UNITED STATES PATENT AND TRADEMARK OFFICE

APPLICATION NO.	FILING DATE	FIRST NAMED INVENTOR	ATTORNEY DOCKET NO.	CONFIRMATION NO.
09/816,932	03/23/2001	Francisco Jose Francisco Pires	GR 00 P 1568	6127

Office Action Summary

DETAILED ACTION

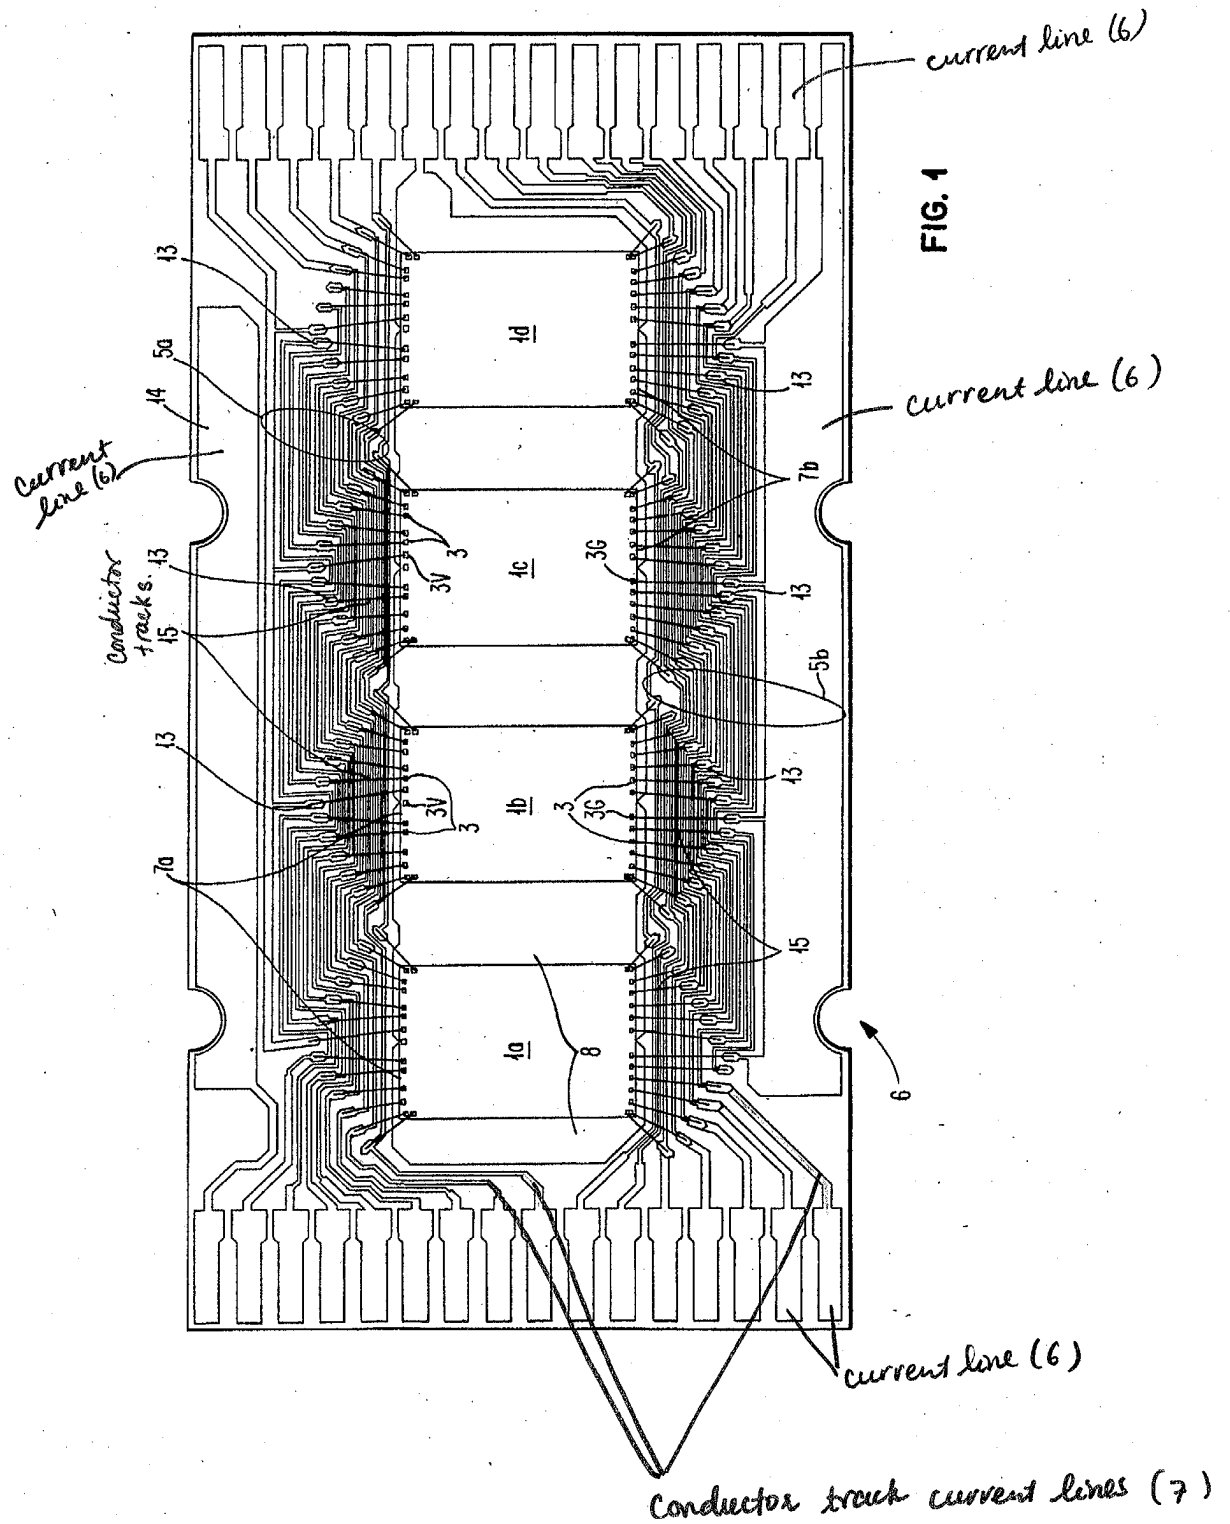
Janai et al. disclose in Fig. 2 (also see attachment for details) a conductor track layer structure precursor stage having a plurality of conductor track disposed on an electrically insulating substrate; said electrically insulating substrate having an inner region and a lateral peripheral region; the conductor tracks connected via conductor track current lines (36) to at least one current line (38); wherein the current line extends in the lateral peripheral region of the conductor track layer structure precursor stage; the conductor tracks are each connected to the at least current line via a separate conductor track current line, and the conductor tracks inside

- conductor tracks (2)
- conductor tracks lines (7)
- current line (6)
